BARN OWLS HORSHAM RD COWFOLD RH13 8AL

PROPOSED LAYOUT
SCALE 1:100
AUG 2024 DRG Nº 2.2

REV
1. SCALE BARS ADDED
2. AIR SOURCE HEAT PUMP RELOCATED & ELEVATIONS SHOWN.
3. MATERIALS ADDED.

PROPOSED IMPROVEMENT TO ROOFING FABRIC
U VALUE 0.35
1:10

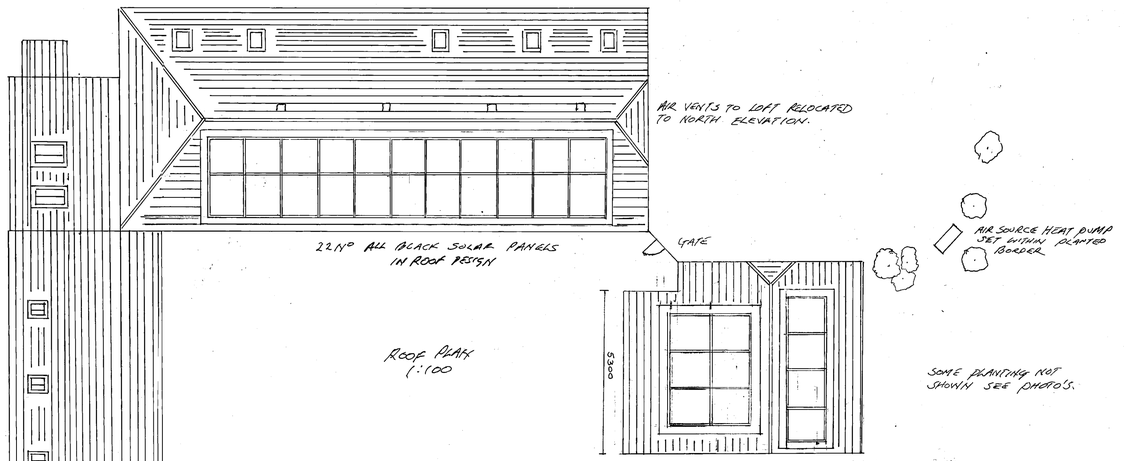
FOLLOWING CONVERSATION WITH B.C.O JON HADDOCK WHO CONFIRMED SATISFIED WITH THE EXISTING 'U' VALUE OF 0.35 AND THAT IT WAS NOT PRACTICAL TO INCREASE THE DEPTH OF INSULATION.

IT WAS RECOMMENDED TO CHANGE THE FLAMABLE POLYSTYRENE INSULATION FOR A MODERN CLOSE BONDED AIR BOARD AND USE SEALING TAPE TO SIDES. MCS APPROVED INSTALLER.
